UNITED STATES PATENT AND TRADEMARK OFFICE

APPLICATION NO.	FILING DATE	FIRST NAMED INVENTOR	ATTORNEY DOCKET NO.	CONFIRMATION NO.
10/773,033	02/04/2004	Brian Moon	1251.185	5698
7590	11/30/2006			
Michael A. Slavin, Esq. McHale & Slavin, P.A. 2855 PGA Boulevard Palm Beach Gardens, FL 33410				EXAMINER AYRES, TIMOTHY MICHAEL
				ART UNIT 3637 PAPER NUMBER

Office Action Summary	Application No.	Applicant(s)
	10/773,033	MOON ET AL.
	Examiner	Art Unit
	Timothy M. Ayres	3637

DETAILED ACTION

Hsu '759 Figure 1

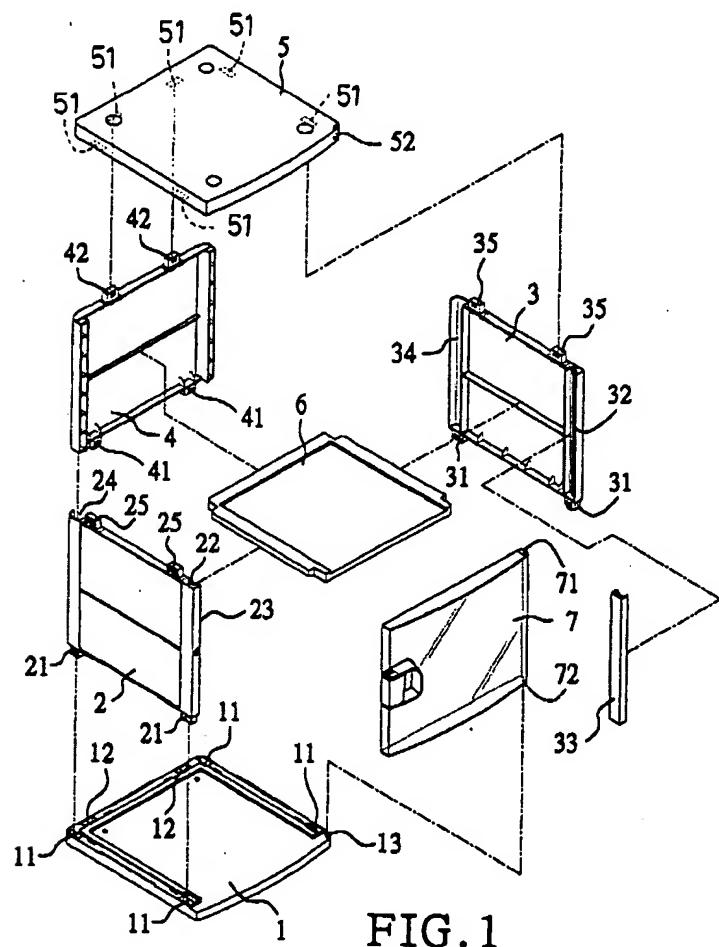
9. Claims 1, 11-16 are rejected under 35 U.S.C. 103(a) as being unpatentable over US Patent 6,474,759 to Hsu in view of US Patent 4,193,649 to Sharon. Hsu teaches a plastic cabinet that can have drawers as seen in figure 11. The cabinet is made up of a base panel (1), top panel (5), left side panel (2), right side panel (3), and back panel (4).

The top and bottom panels (1,5) connect to the side and back panels (2,3,4) with a means for attaching (11, 12 ,51, 21,25,41,42,31,35). The means for attaching (11, 12 ,51, 21,25,41,42,31,35) is posts (35, 42, 25, 21, 31, 41) on the side and back panels (2,3,4) that have integrally formed spring tabs (A') that communicate with locking sockets (11,12, 51) in the base and top panels (1, 5) as seen in figure 1 and 7 below.

Sharon '649 Figure 4

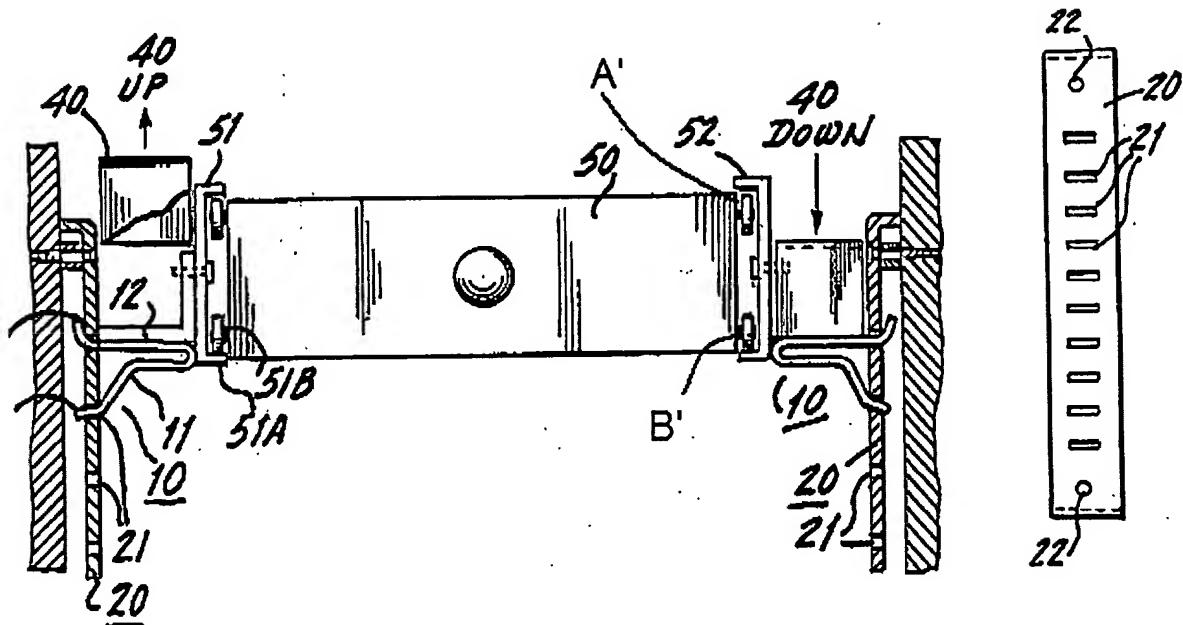
various sized drawers, and the drawer with upper and lower rollers. Sharon teaches drawer glide system that includes drawer glides (51, 52) that have clips (10) to insert into apertures (21) on a vertical rail (20). The glides (51,52) are considered to have a general L-shape. This system allows for different sized drawers to be used in the cabinet. (Col. 1, lines 39-44). The drawer has an upper and lower roller (A', B') to engage with the drawer glide (51, 52). At the time of the invention it would have been obvious for a person of ordinary skill in the art to modify the cabinet of Hsu by adding the vertical rails and drawer glide structure as taught by Sharon to allow for adjustable drawers (Sharon '649, Col. 1, lines 39-44)

Hassel '874 Figure 5

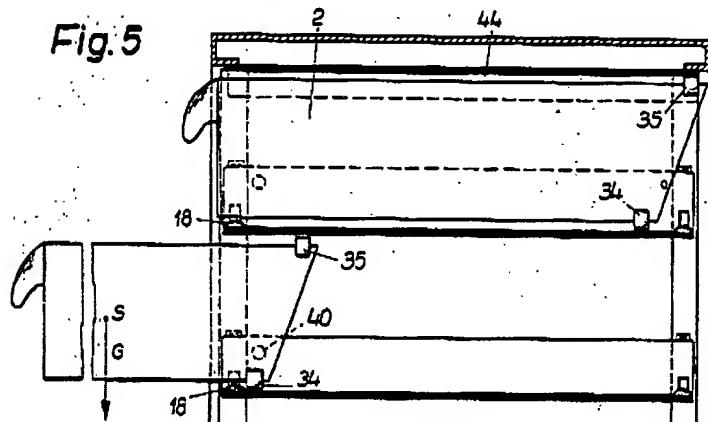
15. Claims 1-4 and 11-16 are rejected under 35 U.S.C. 103(a) as being unpatentable over US Patent 3,572,874 to Hassel in view of US Patent 6,474,759 to Hsu. Hassel teaches a cabinet (1) with drawers (2). The drawer glides (11) are mounted with locking posts (16,15) that have a conjugate shape and extend through apertures (9) in integral vertical rail (8) that are formed on the side wall (3). The drawer glides (11) are L-shaped with a vertical leg (13) and horizontal leg (12). The drawers (2) have slides (34,35) and the rear portion of the drawer (2). A locking member (18) extends through an opening

(17) in the vertical leg (13) of the drawer glide (11) and an aperture (10) on the vertical rail (8) to secure the drawer glide (11) in place. The upper slides (35) contact the bottom of the drawer glide (11) that is above the drawer (2) and the lower slides (34) on the drawer (2) contact a drawer glide (11) that is relatively level with the drawer (2).
